Motorola Mobility LLC.

Product Equality Declaration

The differences between EMEA SS and previous as below:

Previous 711913-01	Current 742708-01

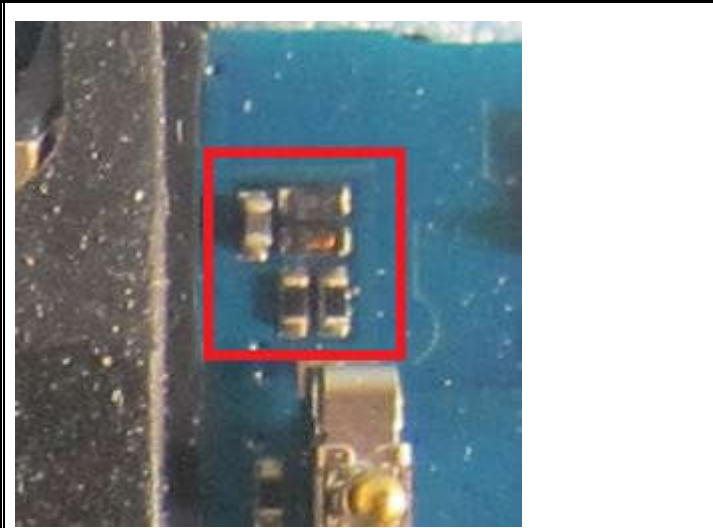
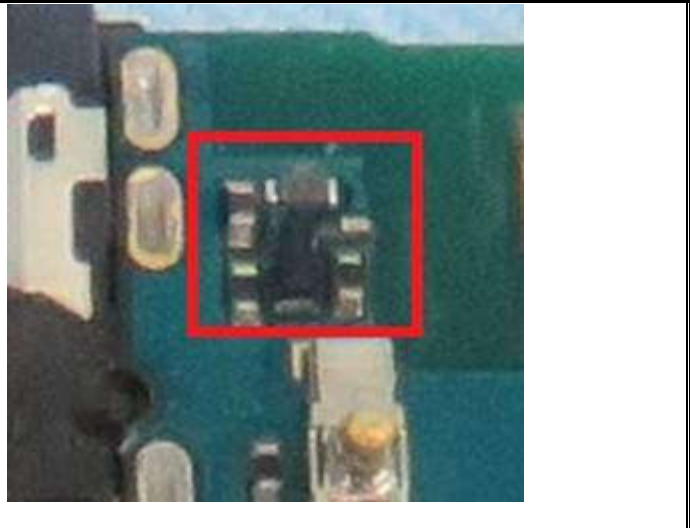
Previous: Manual to remove SAR Sensor Chip and SAR Sensor shrapnel;
 Current: Optimizing the BOM patch and removing the Sar sensor and its matching circuits.
 These changes have no effect on RF.

These changes have no effect on RF.
